## RECALL 20V-761: CHECK 48 V CABLE CONNECTIONS ON STARTER GENERATOR (SGR)

This Service Information Bulletin (Revision 2) replaces SI B12 01 21 **dated February 2021**.

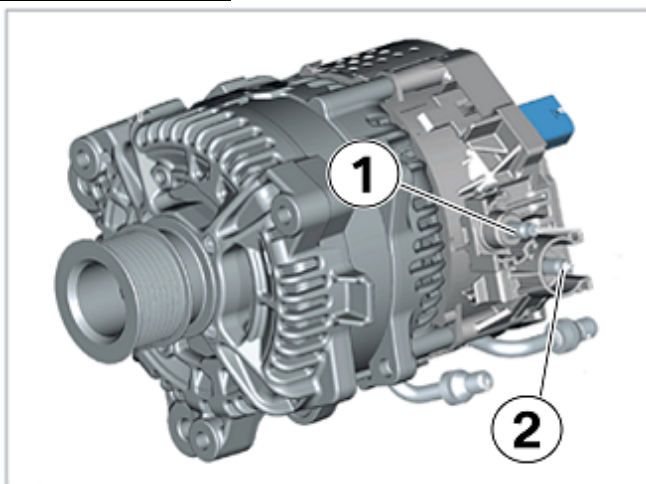
Check the M8 flange nuts and cable connections on the SGR. If necessary, replace the flange nut and torque to spec.

Check the positive (1) and negative (2) cables for play at the mounting lugs on the SGR.

- Deactivate the 48 V electrical system (Repair instruction REP-TAT-P-6124-18-B47\_48V)
- Remove and discard the flange nut on the B+ or B- cable
- Install a new flange nut so that it's carefully started by hand to avoid cross-threading
- Torque to 19 Nm
